Re: Damage Inspection for Occupancy

Inspection Request By: Wiersma Family Trust
Building Address: 116 Lichfield Street
Inspection Date: 7.09.10 / 14.09.10
Building Type: 3 storey brick building with timber floors

earthquake damage report**structex**

project	116 Lichfield Street	project no	5708
date	20th December 2010	from	Sean Gardiner
client	Cunningham Lindsey NZ Ltd (Ref: 423107 JVL)	owner	Weirsmas Family Trust

Collapsed parapet of 116 Lichfield Street above egress stair.

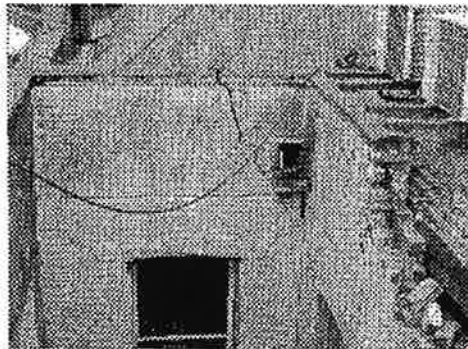
Inspection of the building showed that parapets around the central lightwell were damaged and loose bricks precariously placed.

Until this work has been completed the stair egress should not be used and should be blocked off to prevent access into this area.

Require the loose bricks and parapets to be removed around the lightwell and the stairs reinstated to provide egress if upper floors are to be used.

As a matter of urgency I recommend that the water tanks be decommissioned and replaced with pressure reducing valves. The steel supporting beams removed and parapets removed down to the roof level and the top of the walls over-flashed to provide weather proofing to the gutter.

FIRE ESCAPE N & E walls
Cnr Lichfield & Manchester
Strader, EG
22/9/10

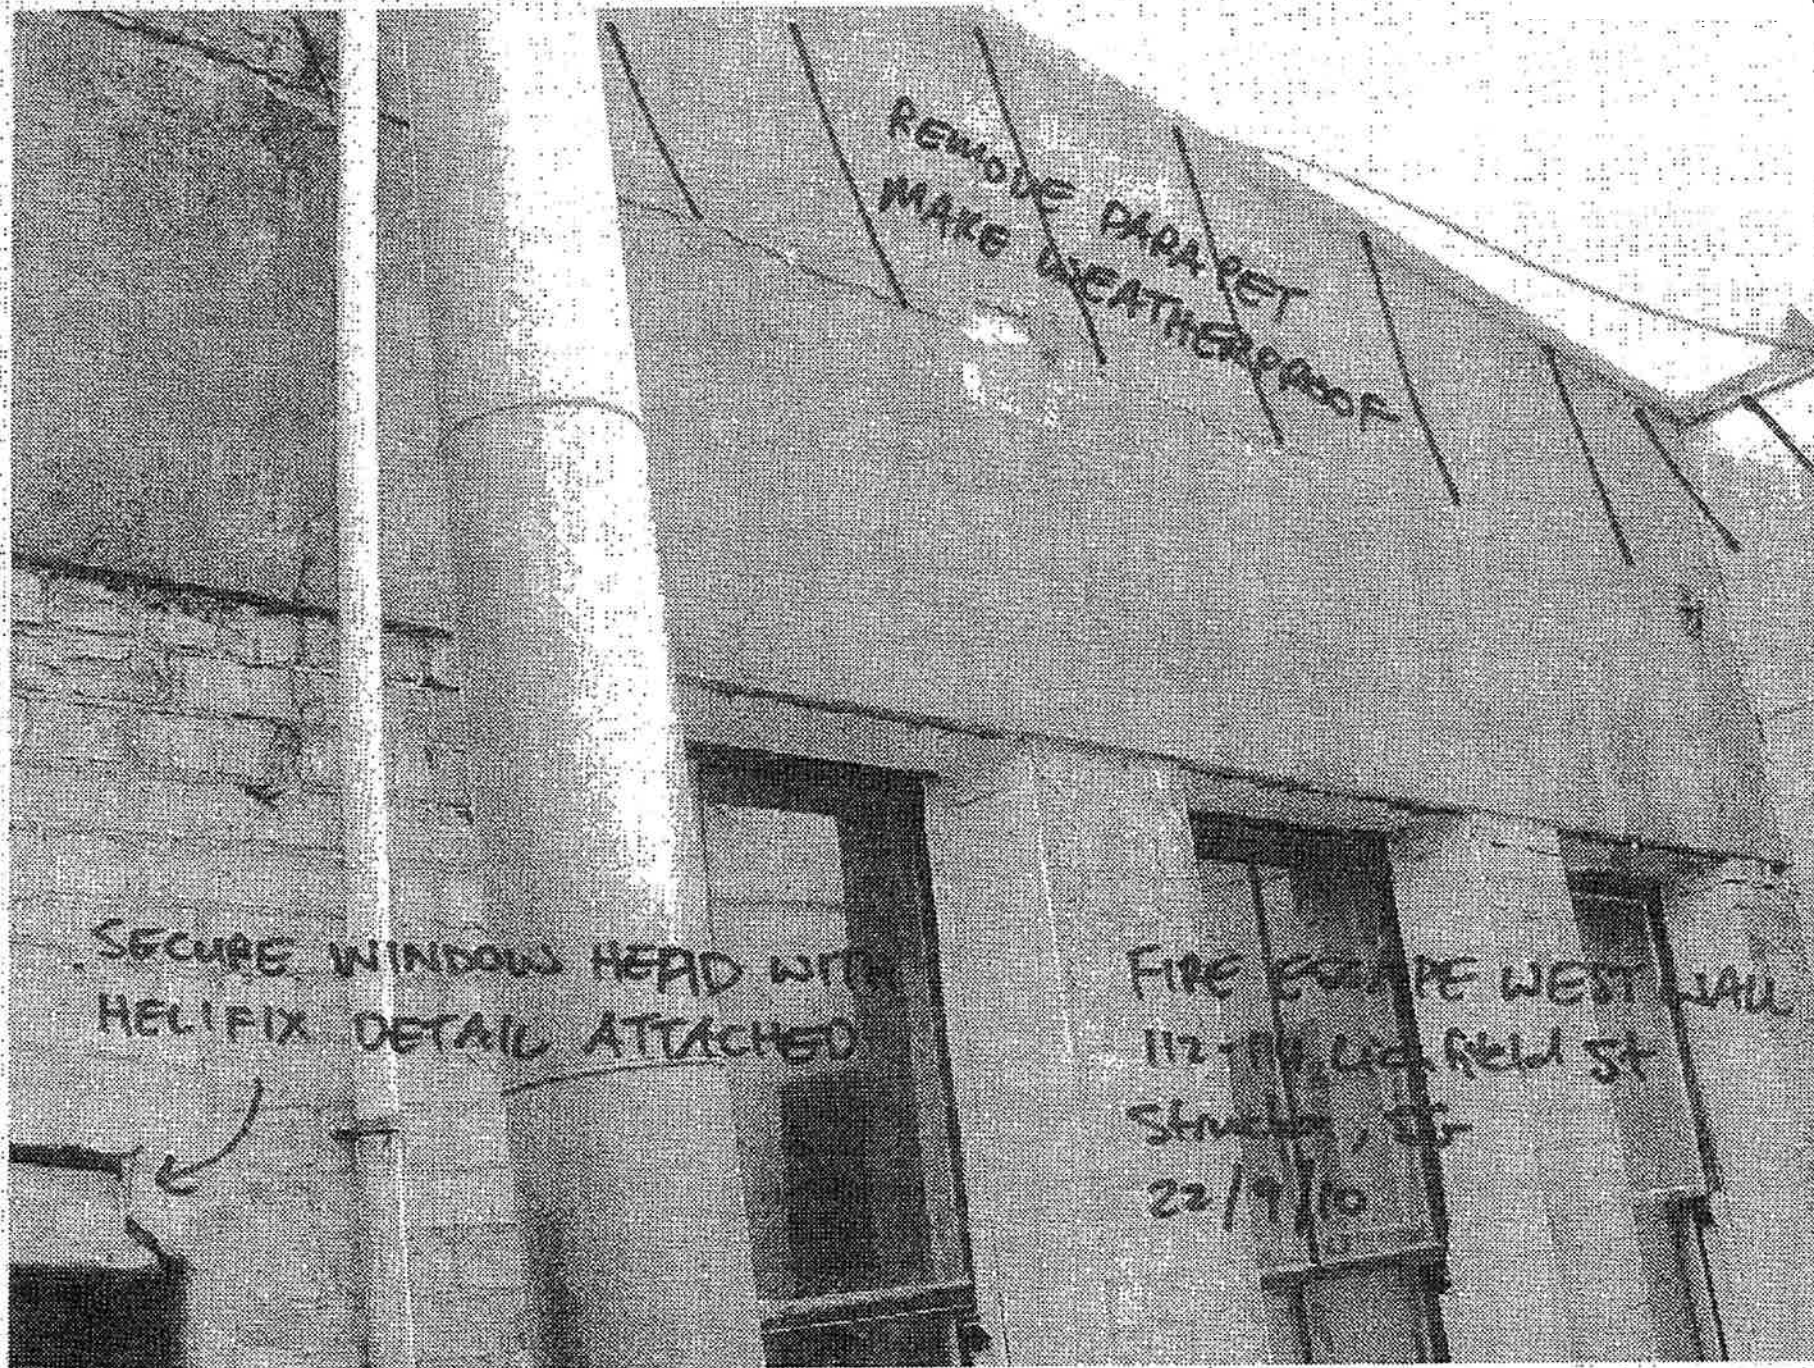
REMOVE PARAPET MAKE
WEATHERPROOF
→

FIX CRACK WITH
REPAIR DETAIL ATTACHED

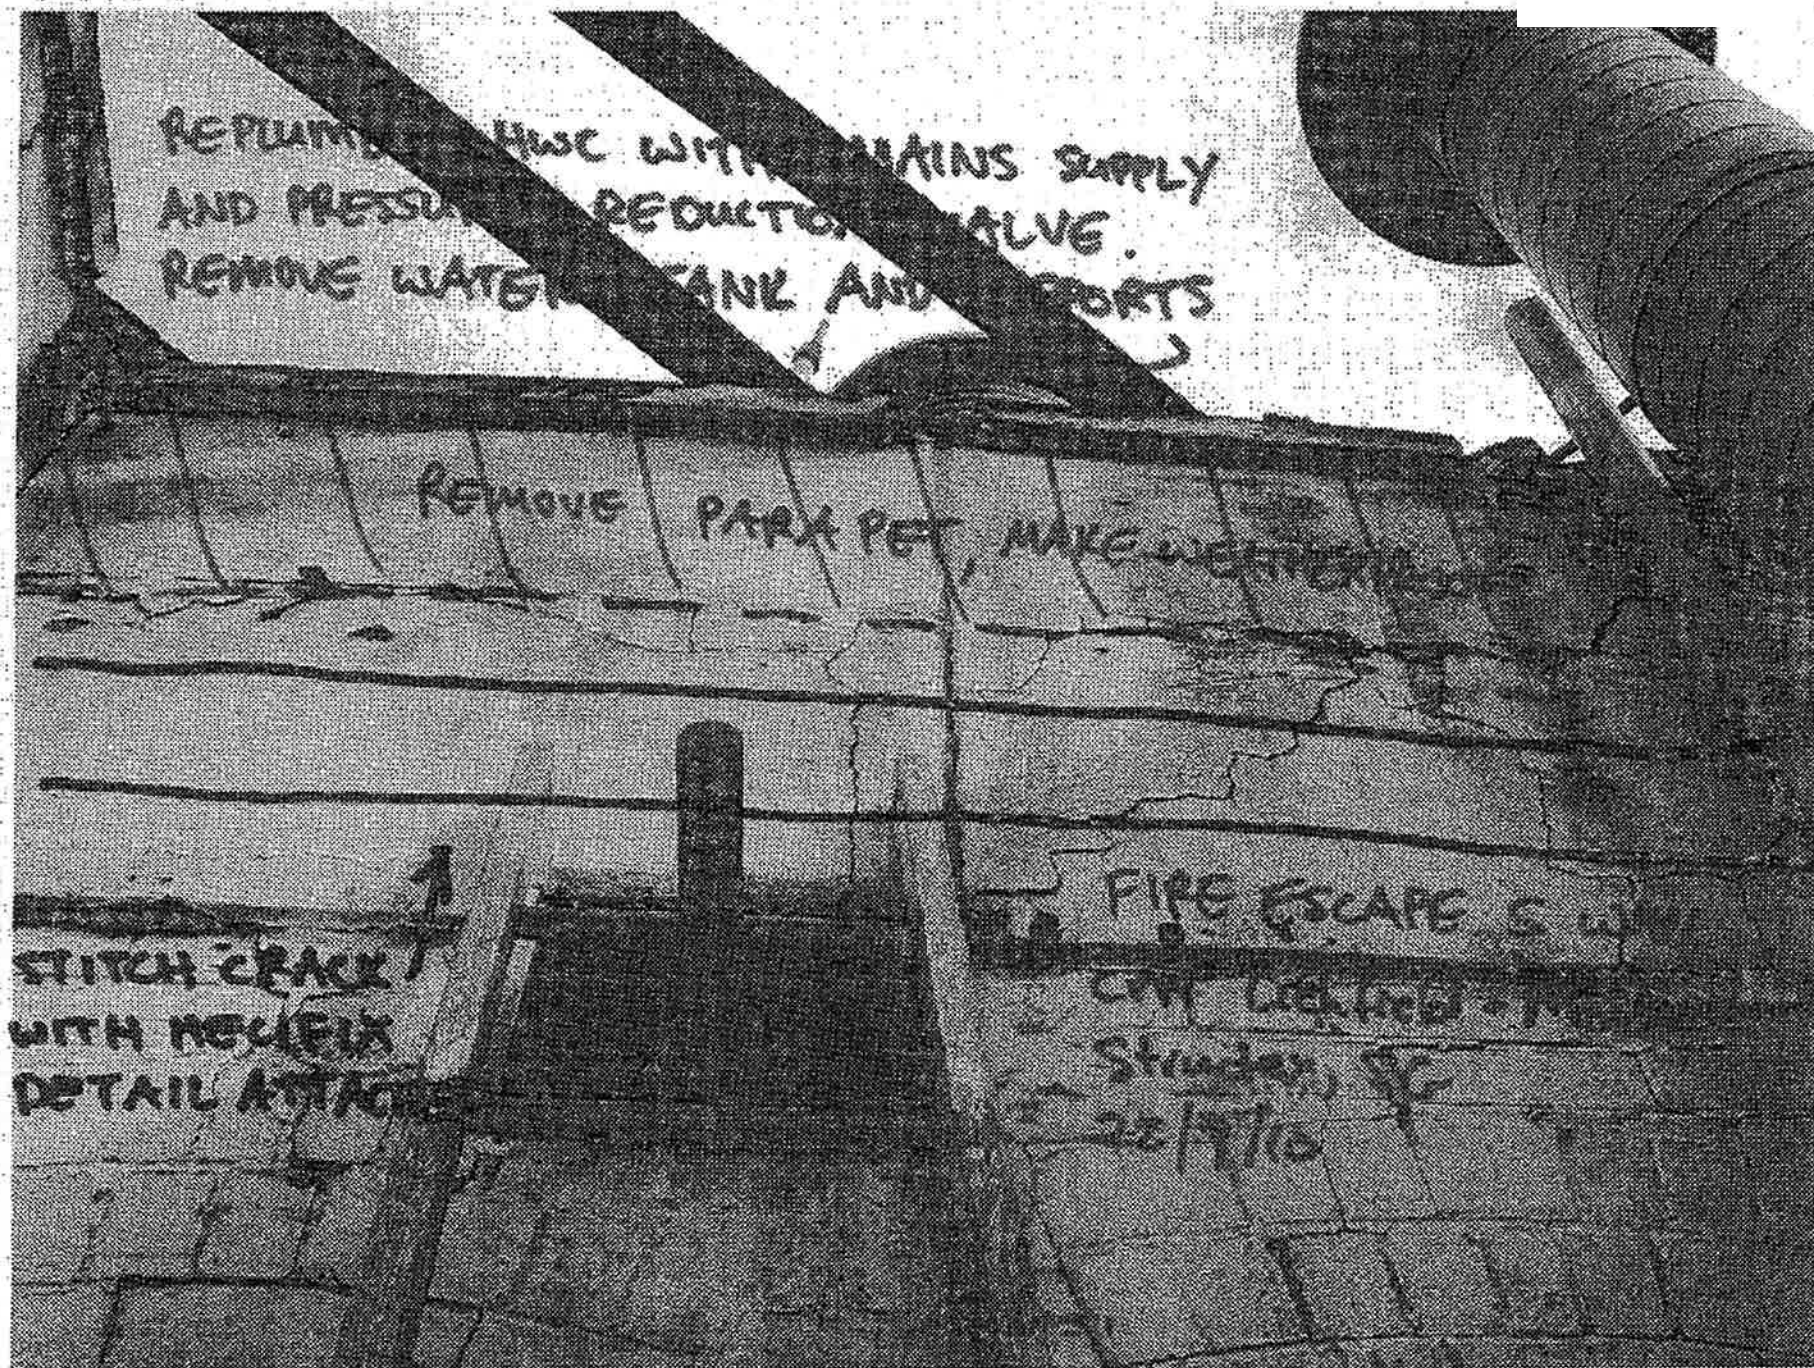
REMOVE LOOSE BRICKS

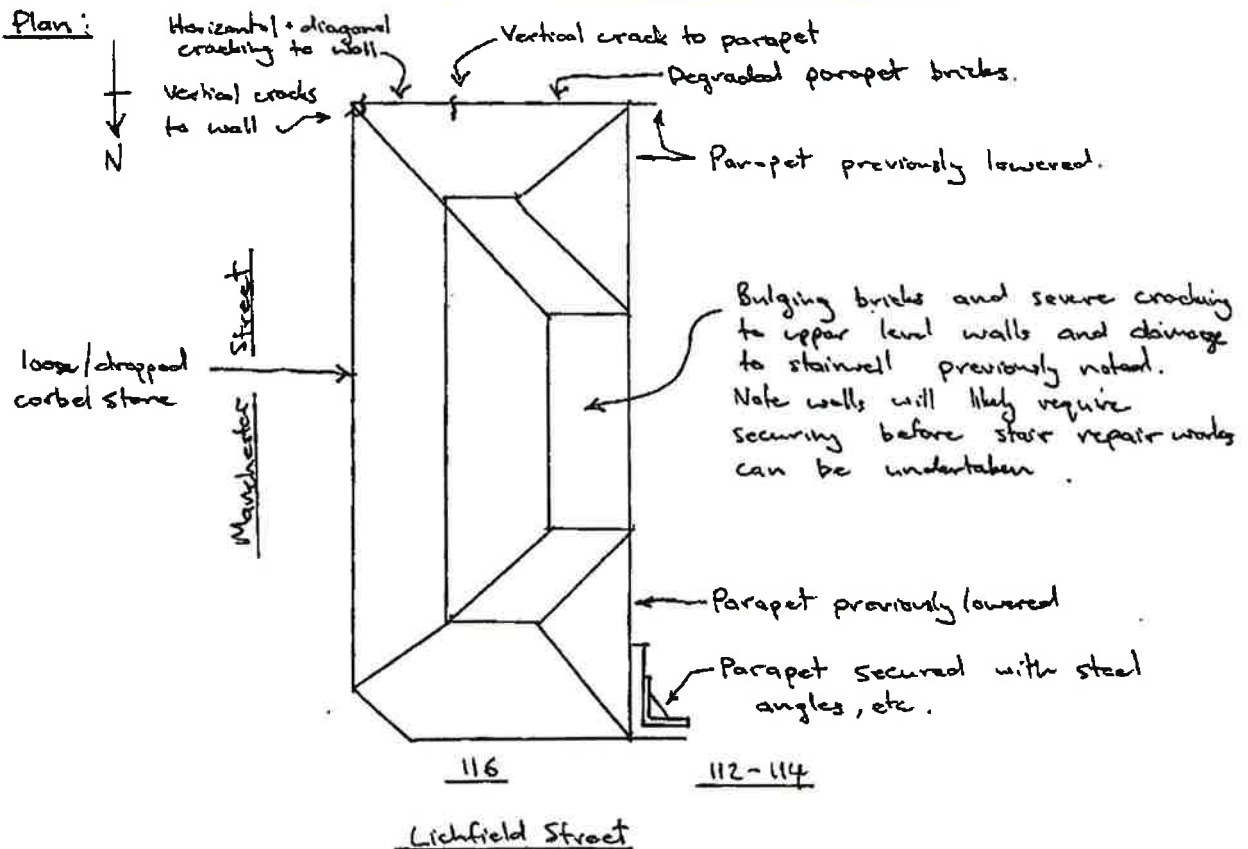
Following advice from contractor we have revisited the property to view further damage from recent earthquakes.

These high level bricks and stone blocks are potential fall hazards to the areas directly adjacent and should be secured as soon as possible, (or the fall areas cordoned off).

Plan (NTS)

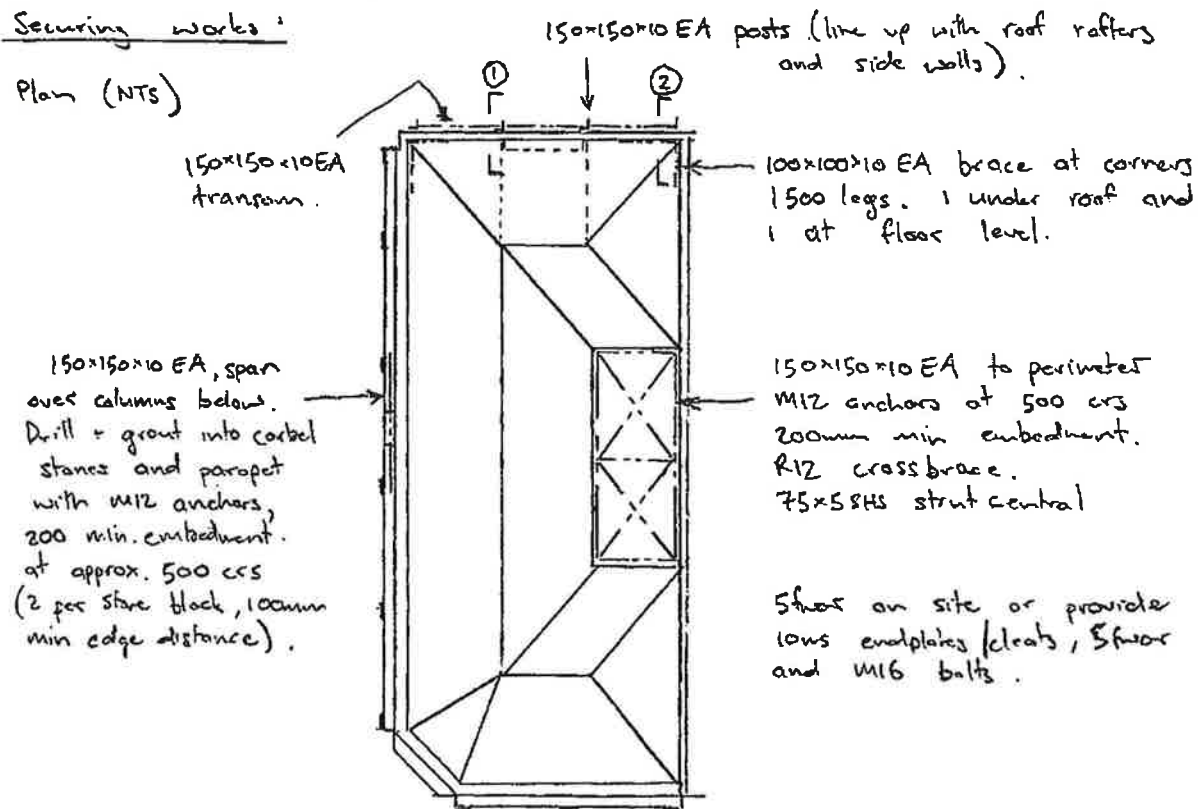
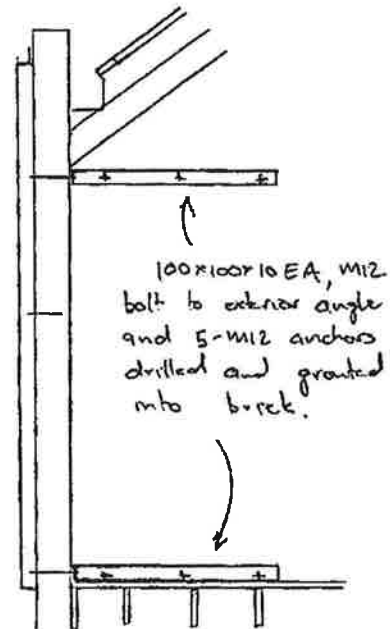
150x150x10 EA transom
fix to parapet
with M12 @
500 c/s.

M12 threaded rod.
(G4.6), 6ms endplate
4 - M12 bolts + 15x35x3
ms washers to rafter.
